CITY OF ALBUQUERQUE

**Re: Sandia Lab FCU
1100 Rio Grande Blvd NW
Traffic Circulation Layout
Engineer's Stamp Date 12-15-2020 (H13-D109)**

**RE: SANDIA LAB FCU
1100 RIO GRANDE BLVD NW
TRAFFIC CIRCULATION LAYOUT
COMMENTS DATED: NOVEMBER 17, 2020**

8" STD C AND G TO 6" TEMPORARY ASPHALT CURB TRANSITION

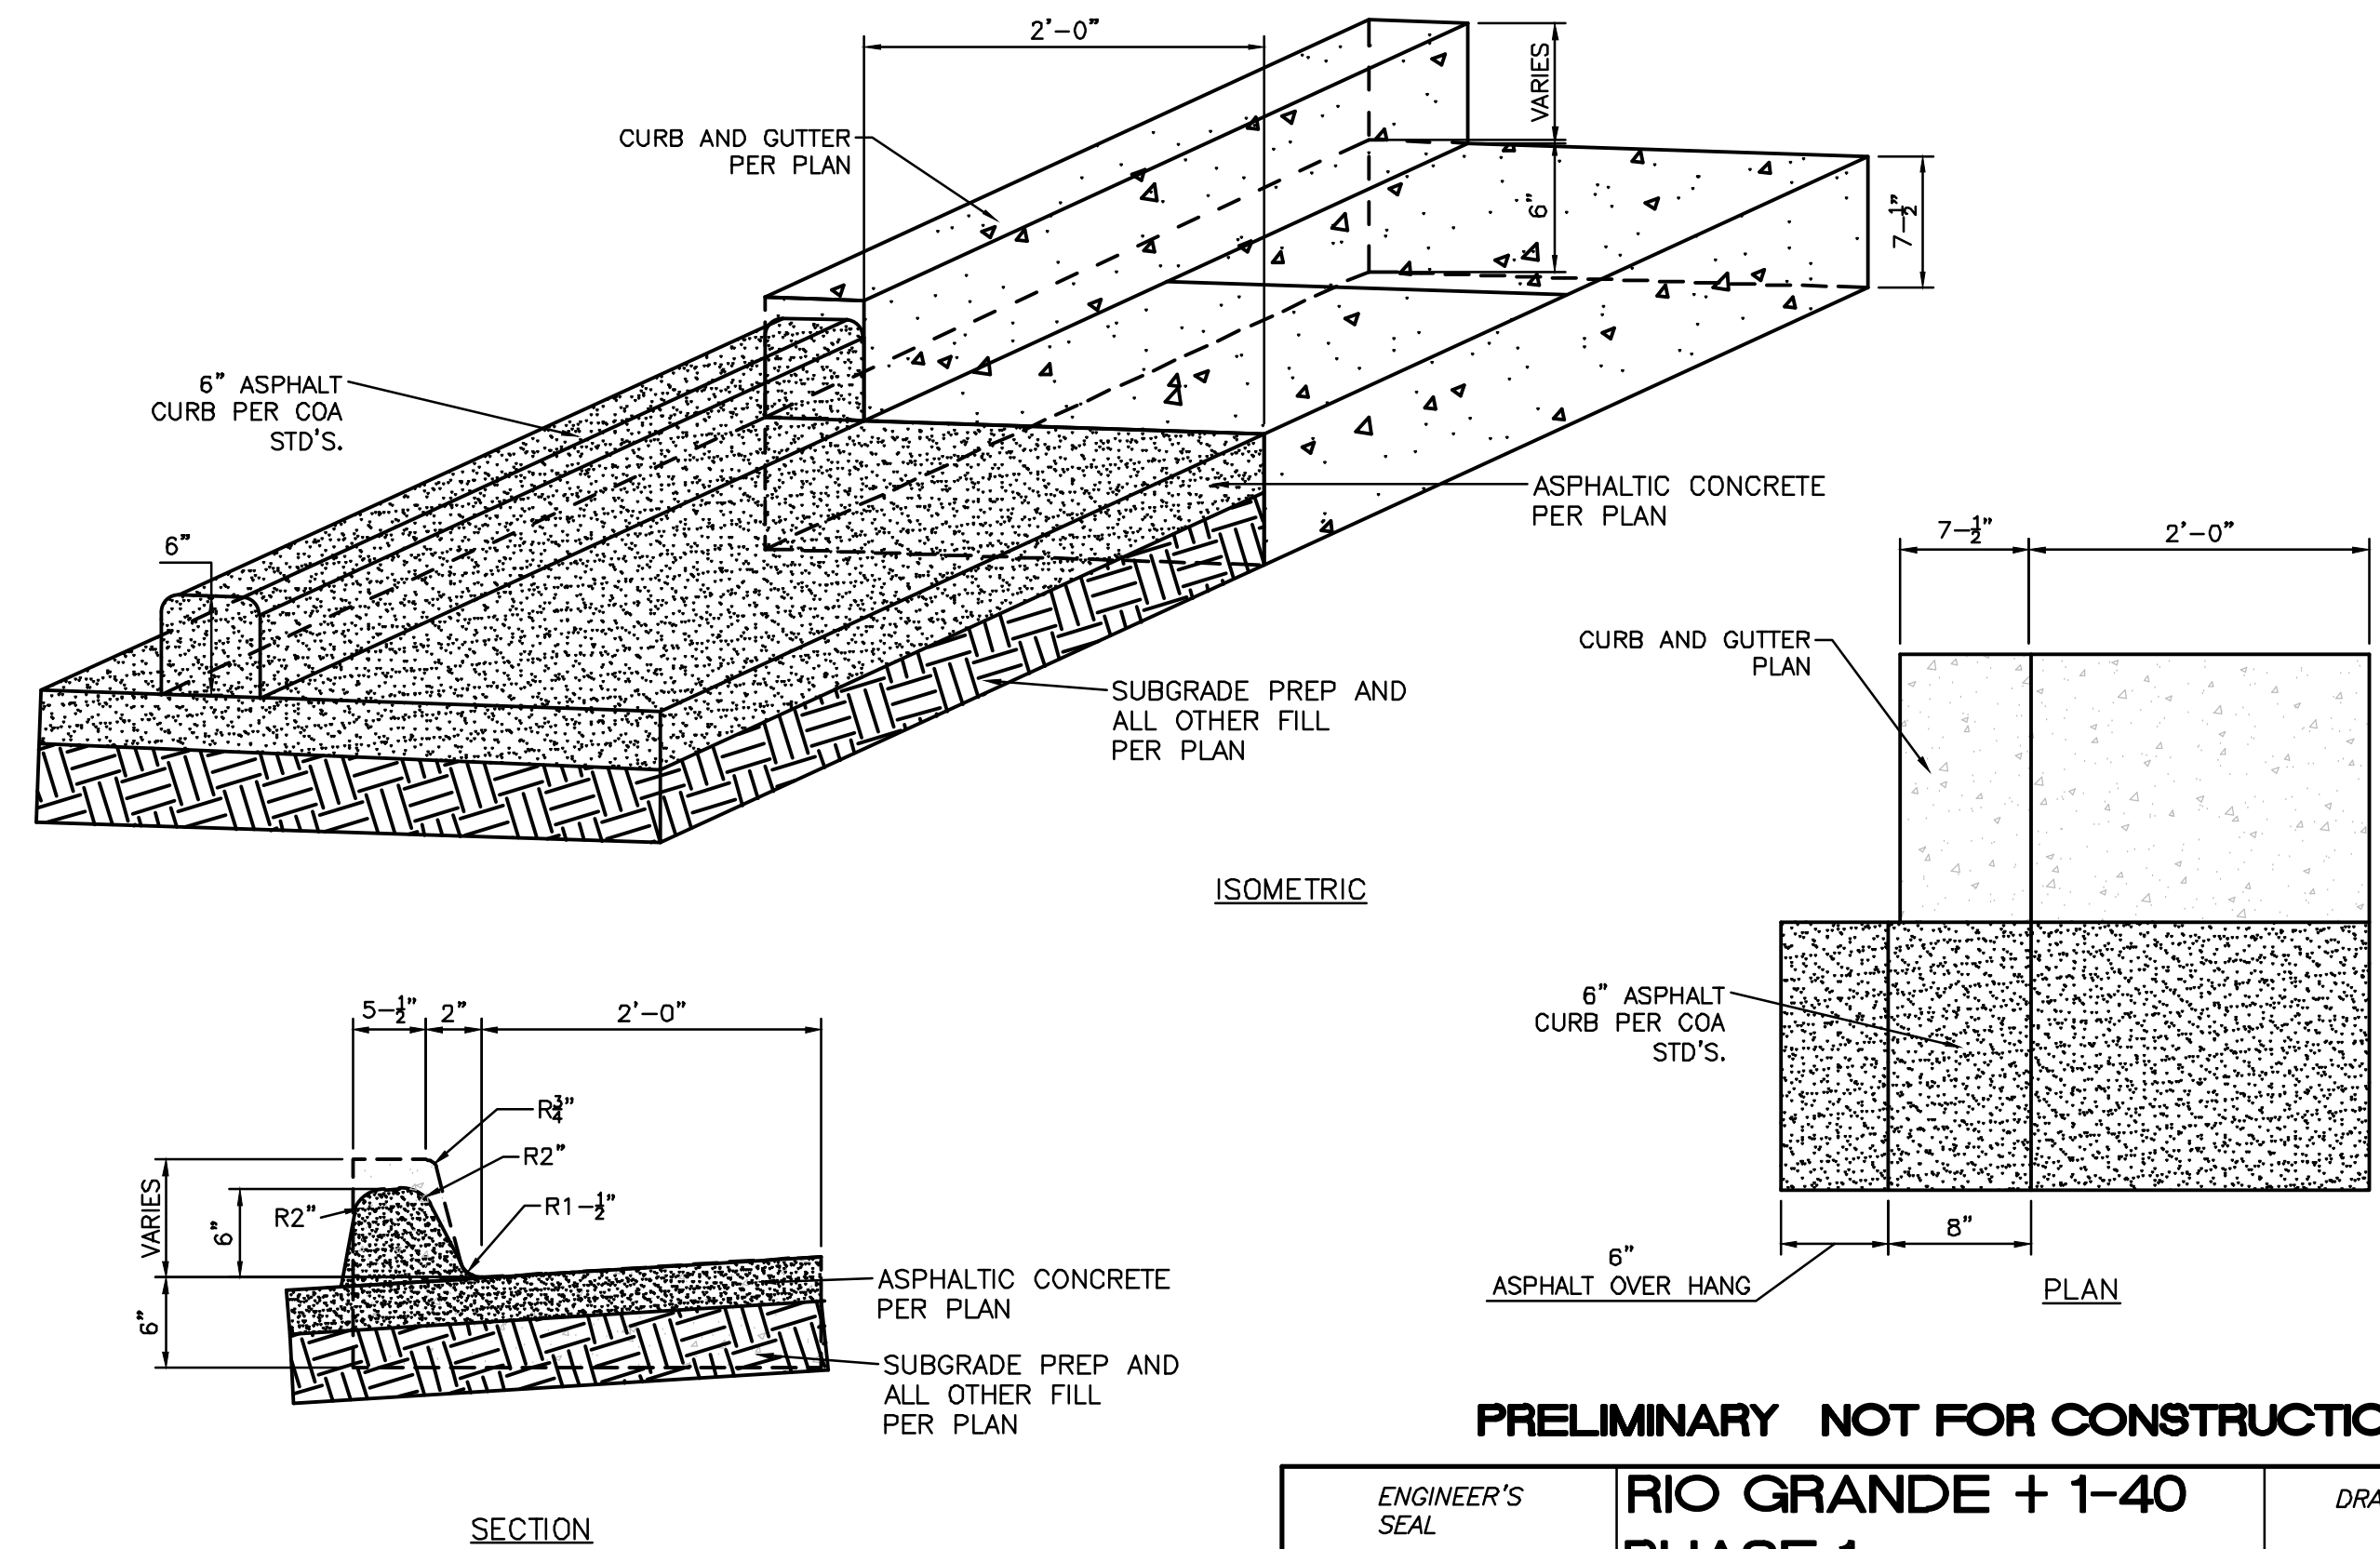
Response: Acknowledged
10. You are proposing temporary asphalt curbing onto the proposed site development why? And need to provide detail on how you will connect a STD C&G asphalt curbing. You will need to provide concrete (STD C&G) at the proposed curb return to your site development lot.

Response: Temporary asphalt curbing is proposed due to the fact that the access drive will need to be modified in the near future to accommodate future developments in the area. See keyed note #7, and a STD C&G to asphalt curb transition detail is provided on sheet C3. Standard C&G will be provided at the curb return, see updated TCL.

DO NOT ENTER SIGN
NTS

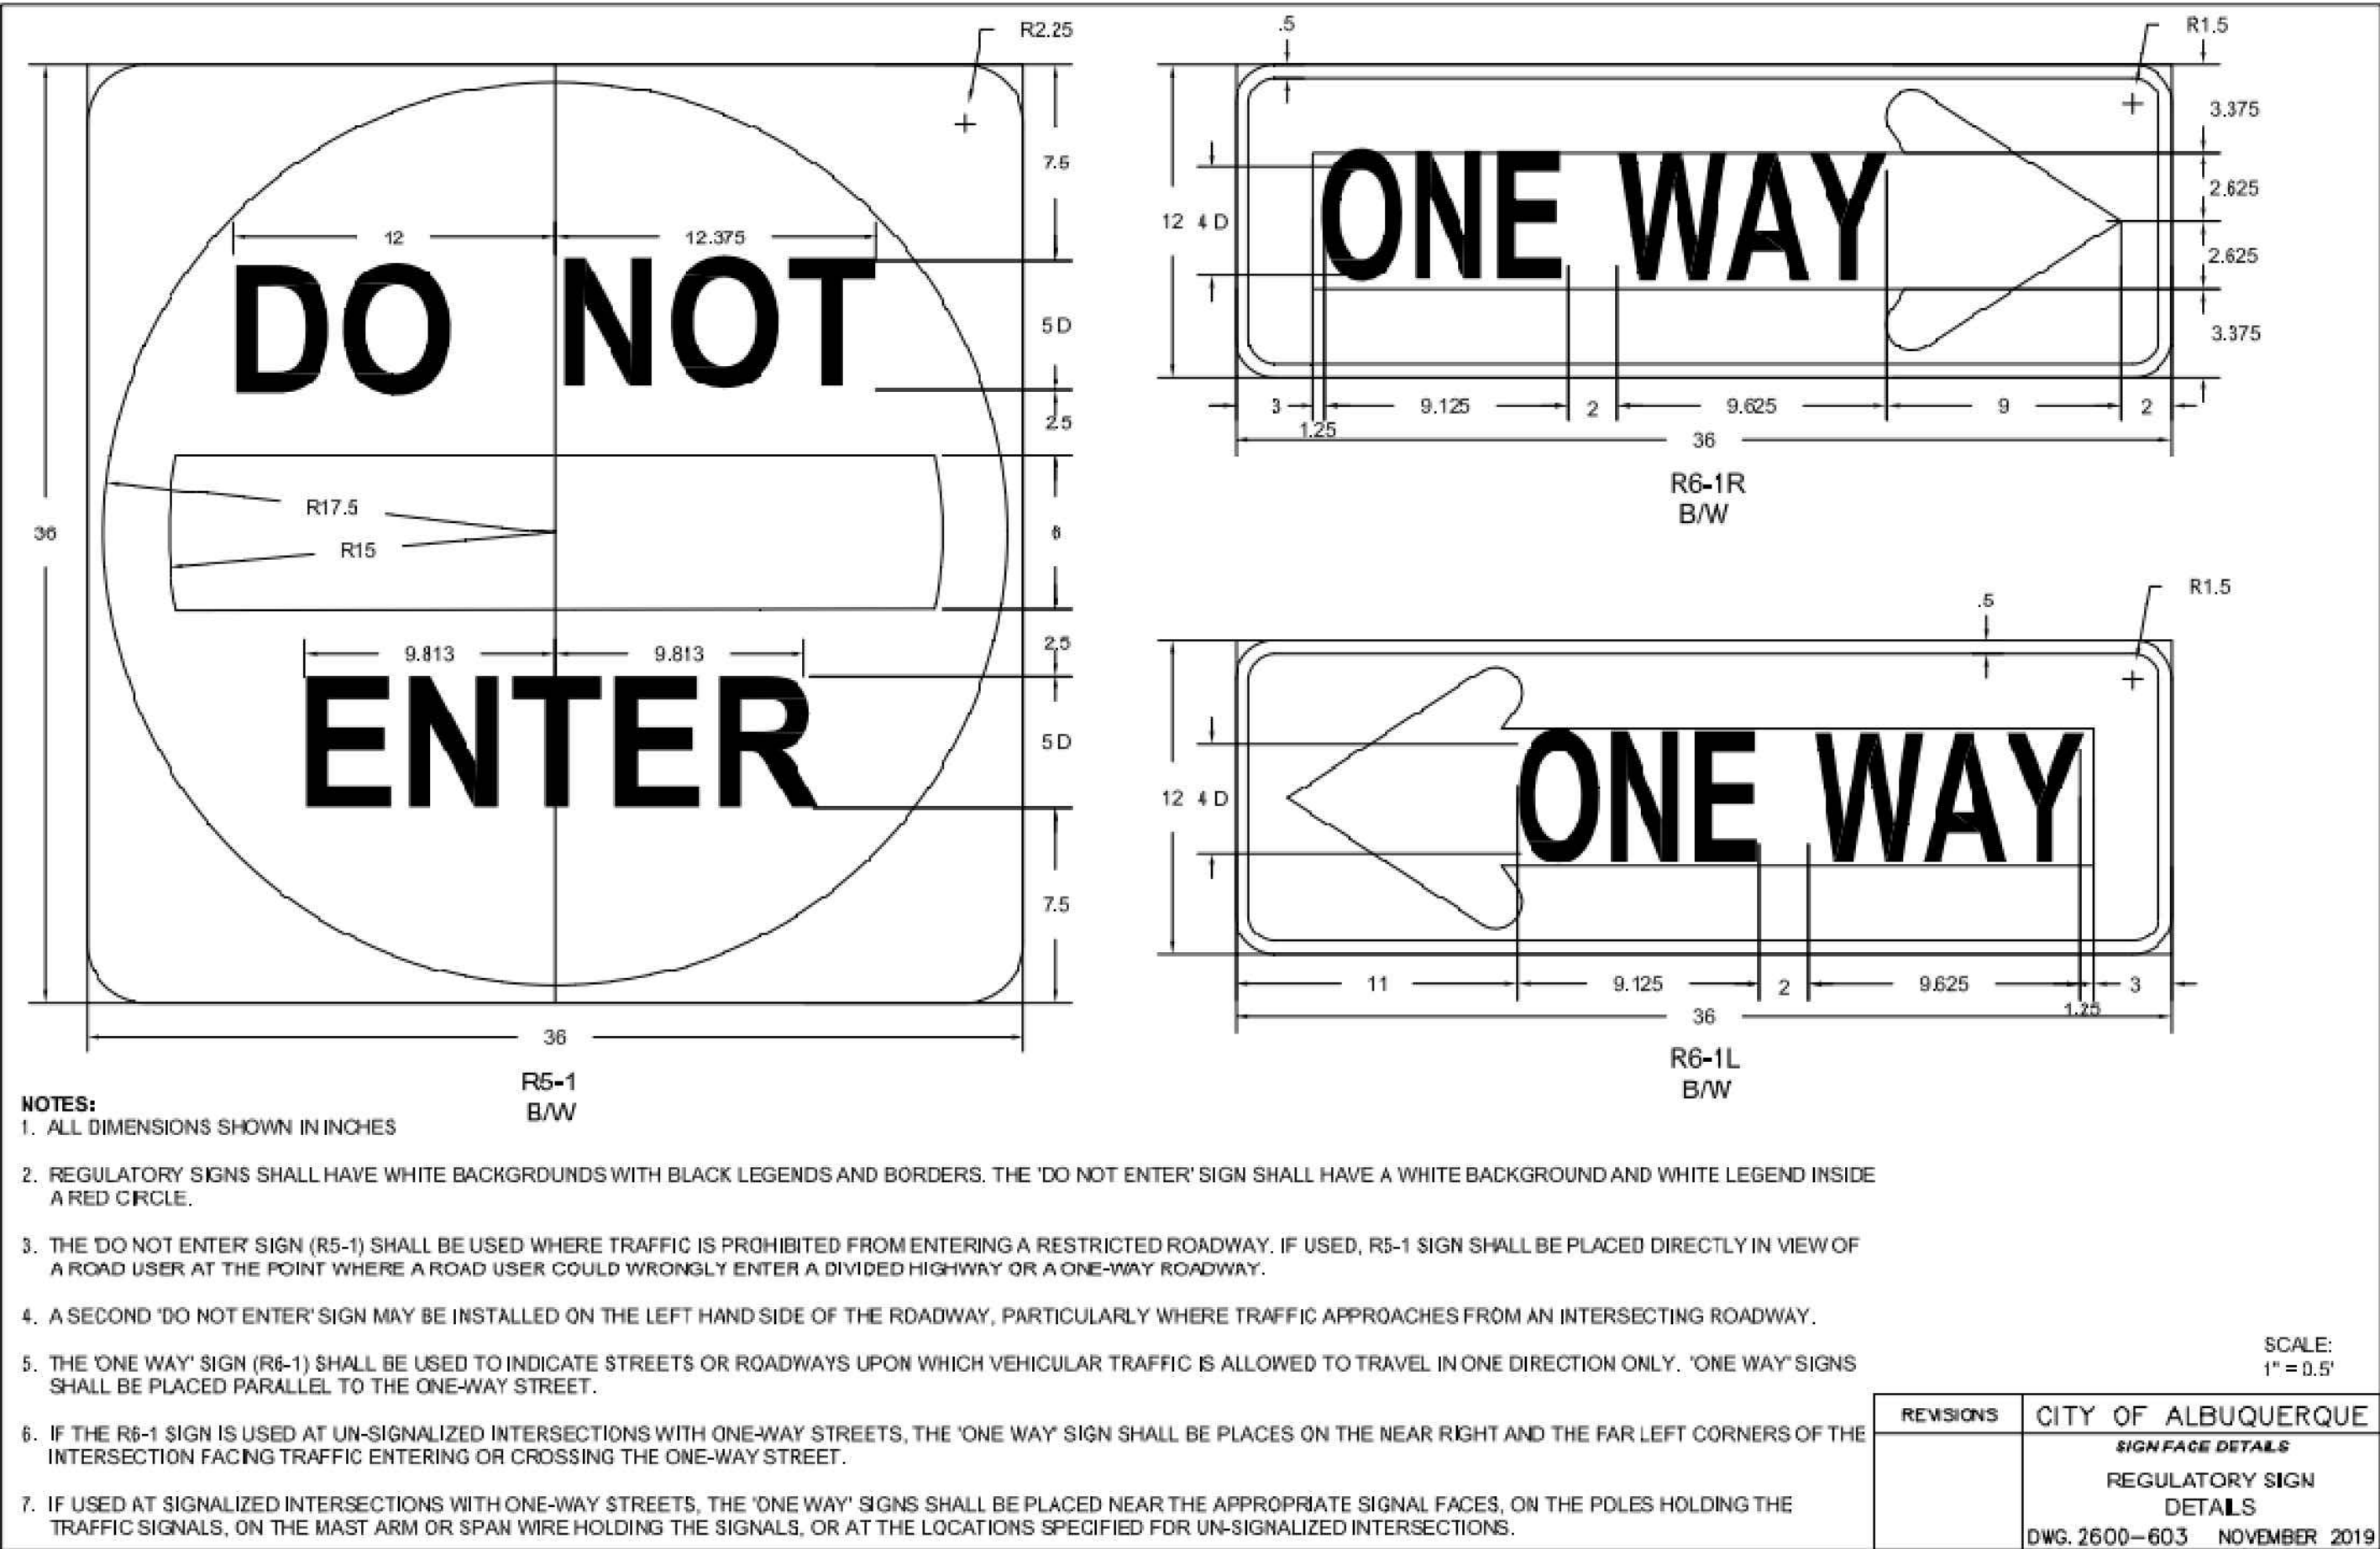
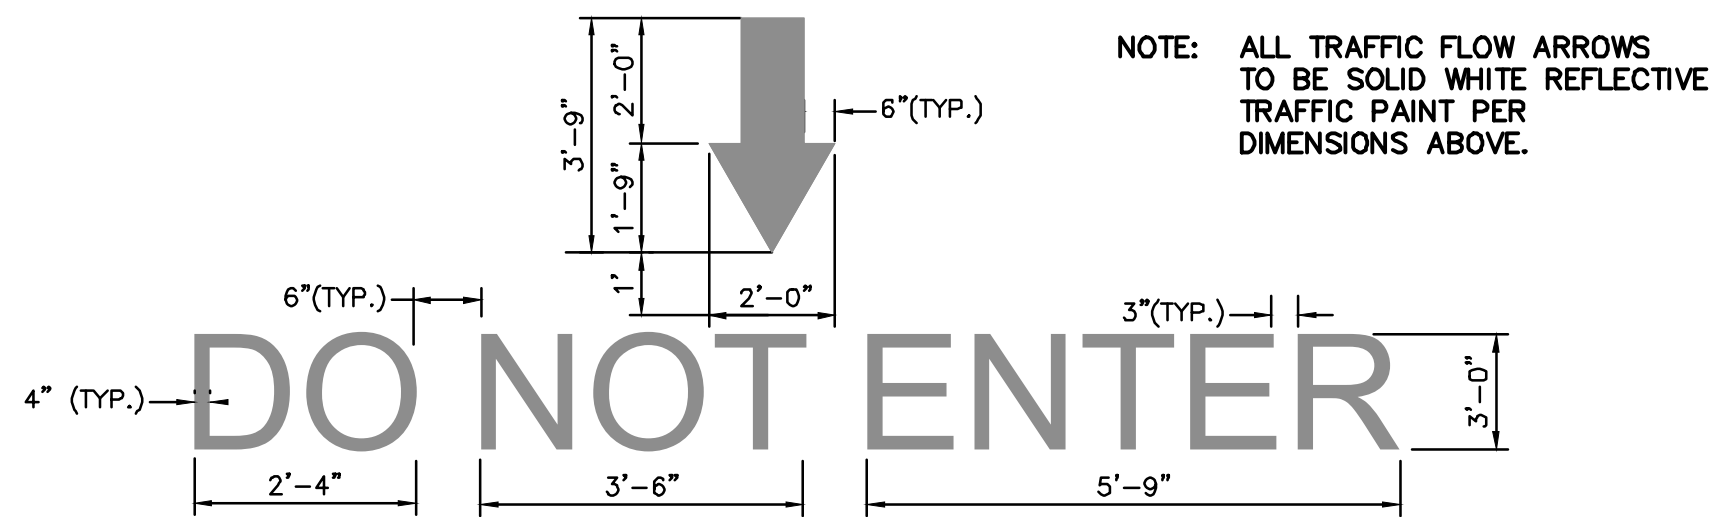
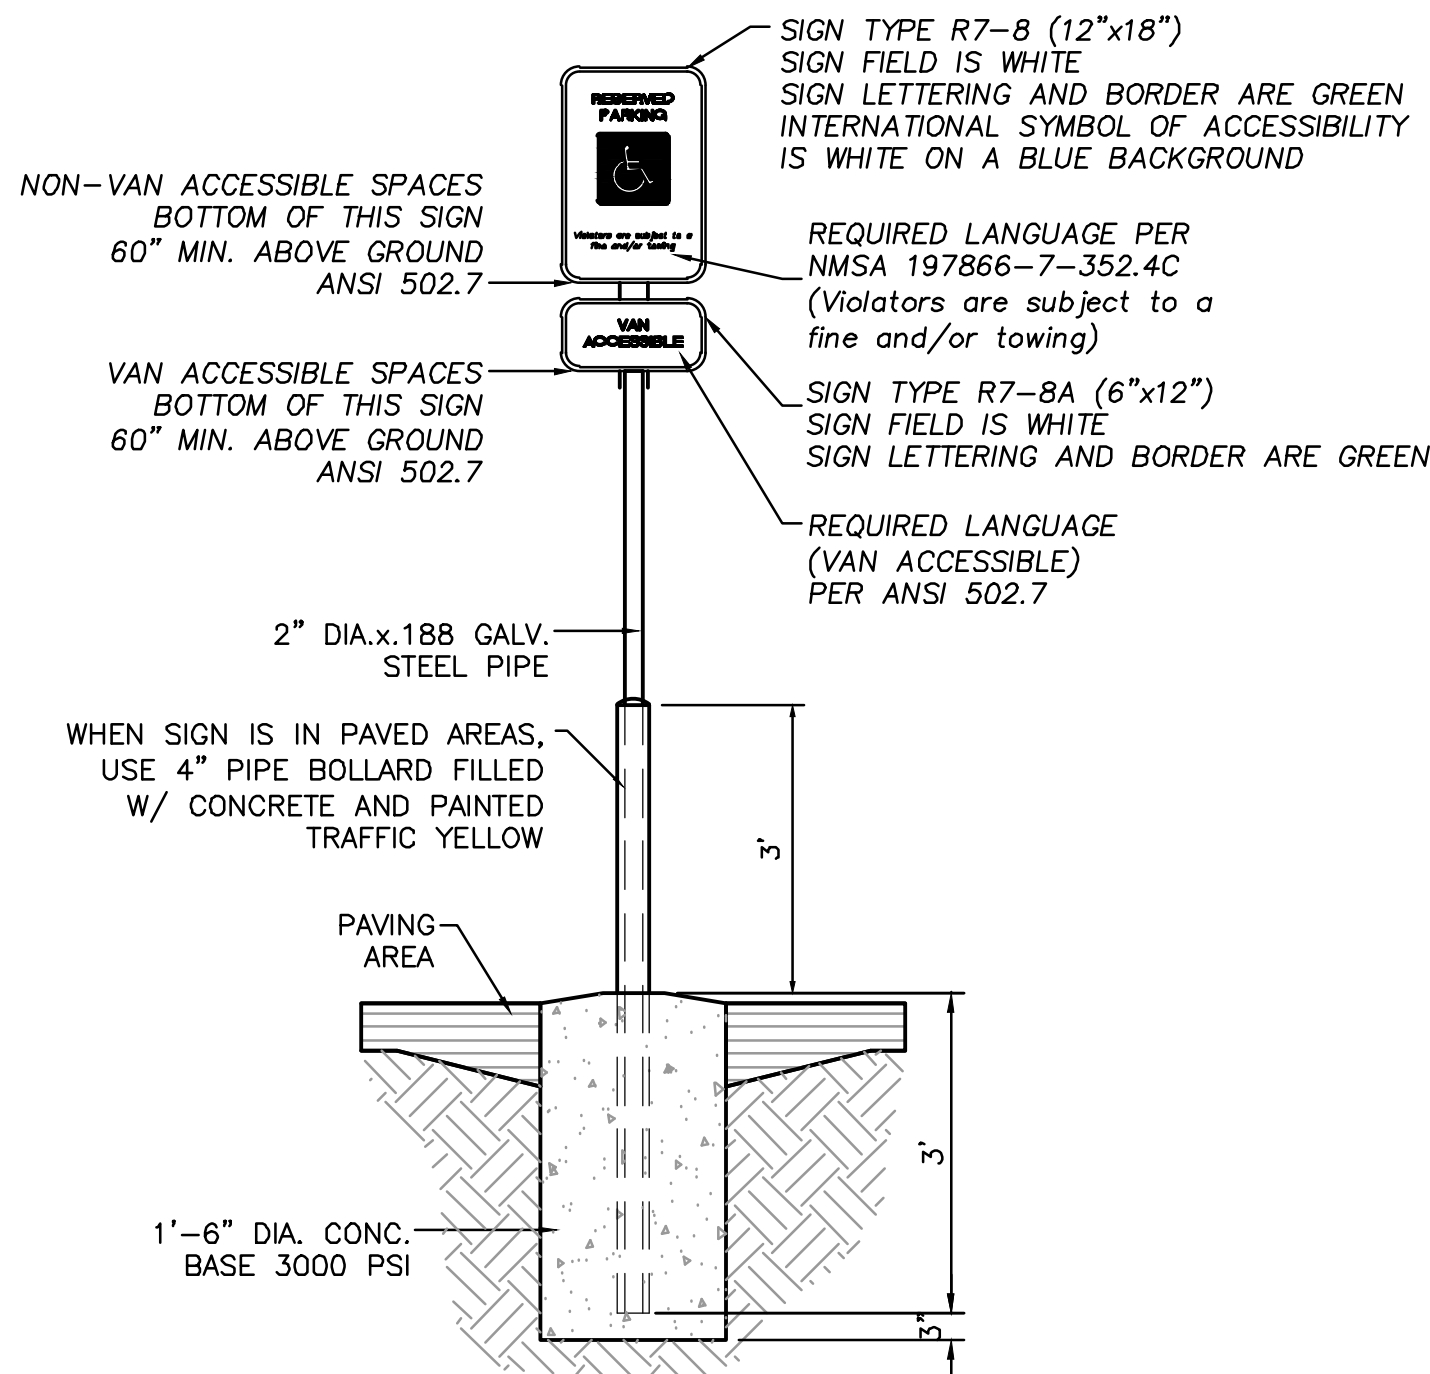
2. Motorcycle parking spaces: Label pavements MC.
Response: Pavement Labeled "MC"
3. All one-way drives shall have "One Way" and "Do Not Enter" signage and pavement markings. Provide details of posted signed and striping.

Response: See Keyed Note #26 and #27, Signage face and striping details added to sheet C5.
4. Provide a way arrows for the proposed drive thru lanes on orientation.
